NSW Planning Assessment Commission

Coalpac Consolidation Project Review: Main Report

14 December 2012

Figure 6-3: 50m Standoff Distance (Source: OEH, letter dated 6 November 2012, Figure E1.1)

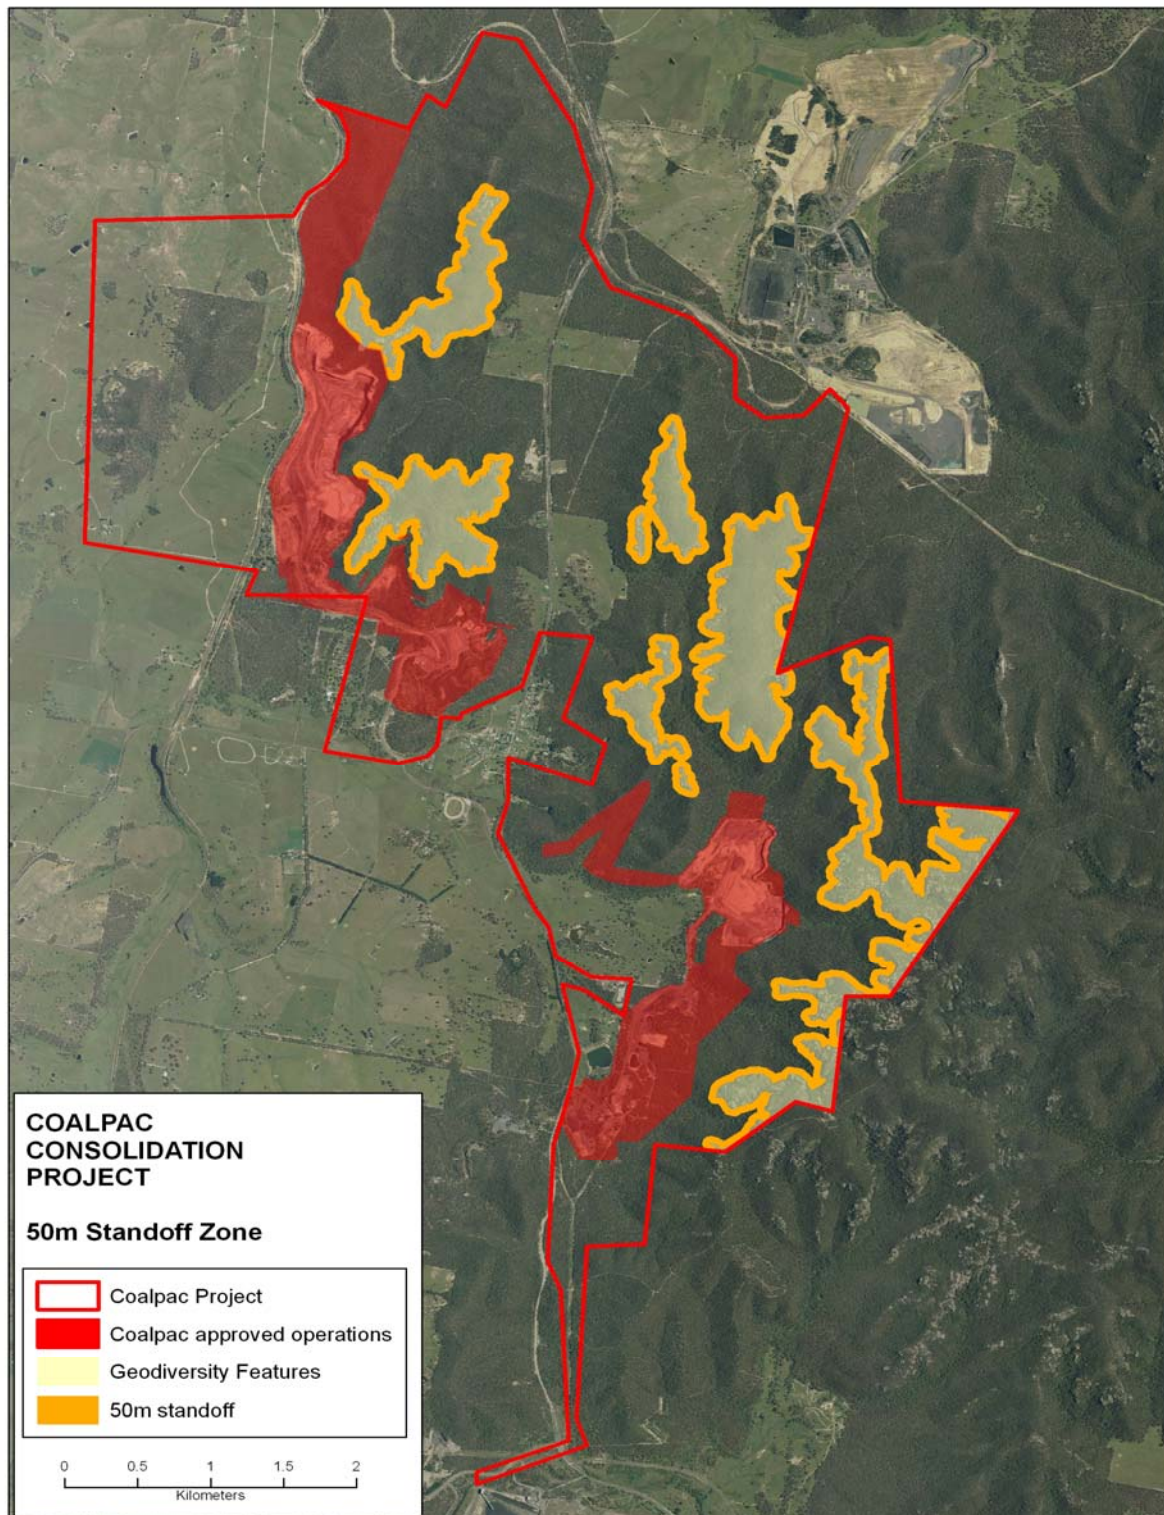
The 50m setback distance is referred to frequently in the EA (it is the only setback distance referred to in Appendix F, which is the relevant Appendix for consideration of stability and subsidence). However, the main report (EA p.45) refers to a standoff zone of only 20m from any significant exposed outcrop or formation that does not fall under the categorization of *‘pagodas or significant sandstone cliffs or escarpments’*. The location of the *‘sandstone pagodas and escarpments’* within the project area is outlined in Figure 5 of the EA.¹⁶⁴ However, there are some differences of detail between Figure 5, and Figure 6-3 in this report. The map in Figure 5 of the EA is of relatively poor quality. The map in Figure 6-3 over the page was produced by OEH using sophisticated equipment.¹⁶⁵ It should also be noted that the Colong Foundation asserts that the pagodas and escarpments have not been accurately mapped in the EA.¹⁶⁶

Figure 6-4: All Standoff Distances (Source: OEH, letter dated 6 November 2012, Figure E1.2)

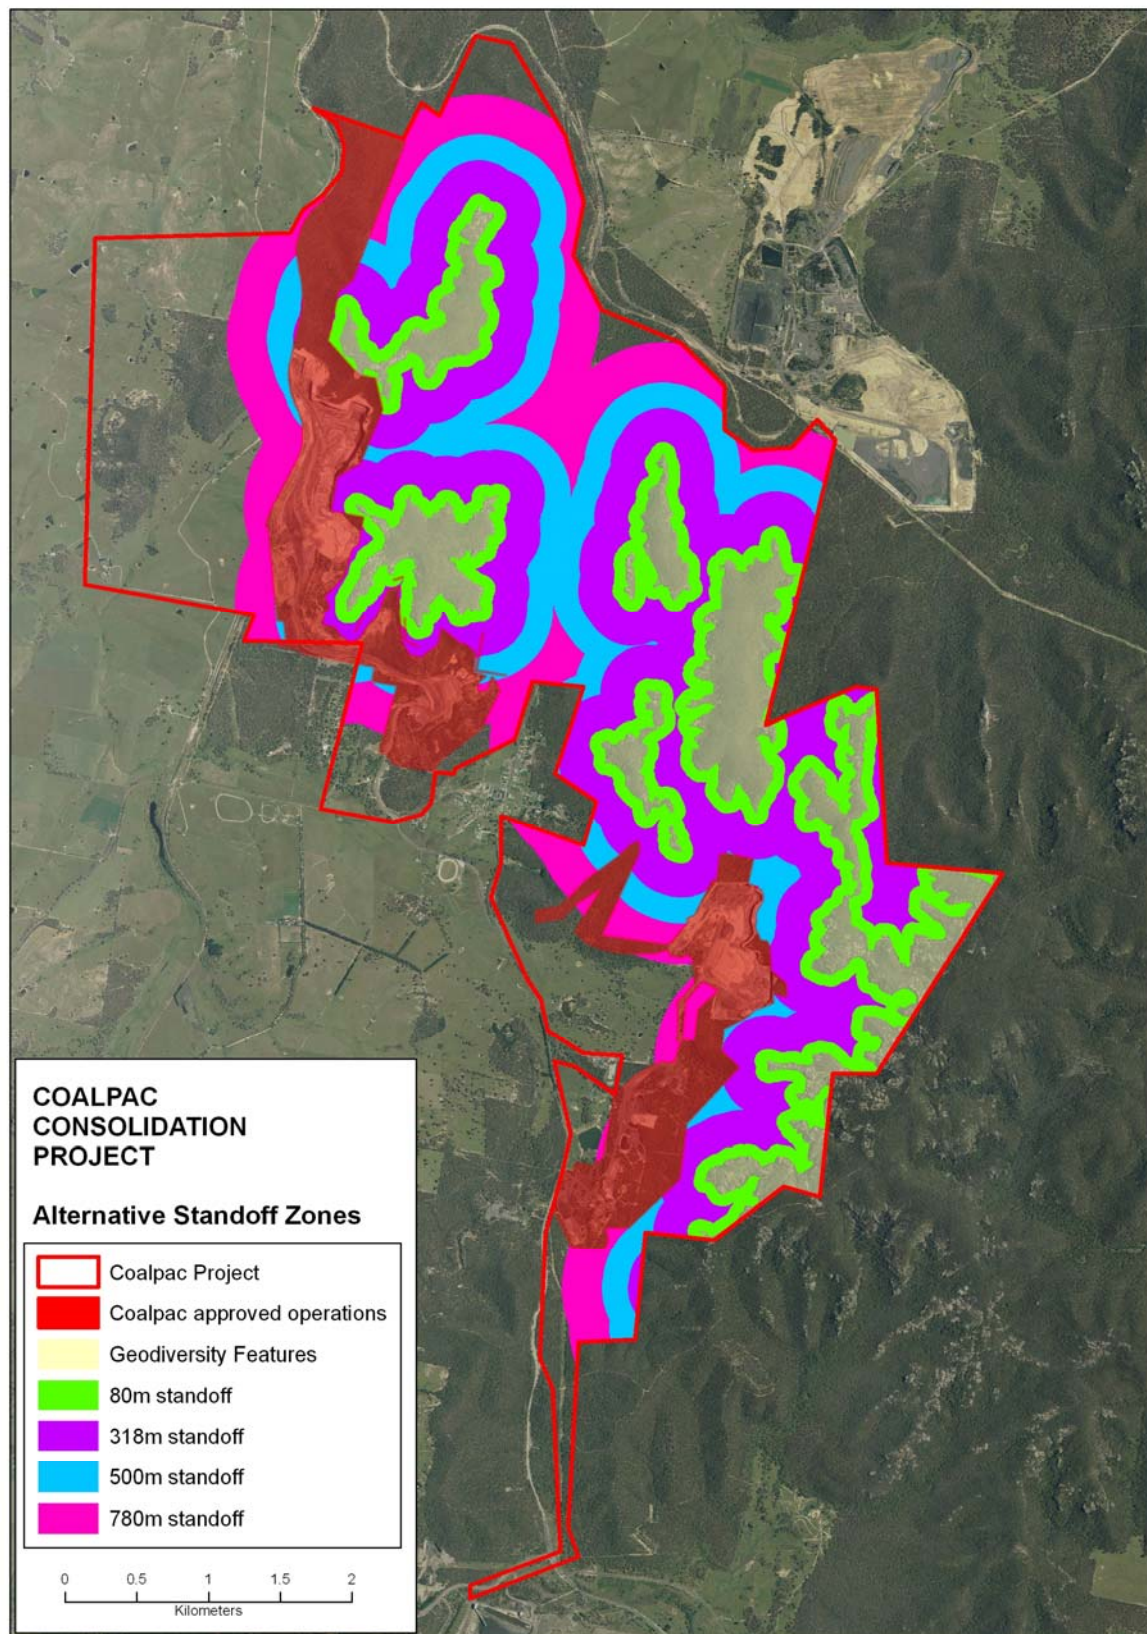
- Mapping increasing setback distances from the pagodas and cliff lines to meet essential habitat requirements for listed threatened species demonstrates just how much the pagodas and cliff lines divide up the project area. A full 500m setback (as per TSPD requirements) would eliminate much of the open-cut (see Figure 6-4 over the page). This suggests that open-cut mining may not be the optimum use for this area which has such high scenic, conservational and recreational value;

Recommendation 47: The Commission recommends that to provide adequate protection for threatened species and other fauna that use the pagoda landform, a minimum setback distance of 300m be maintained from the open-cut highwall to the pagodas and the escarpments.
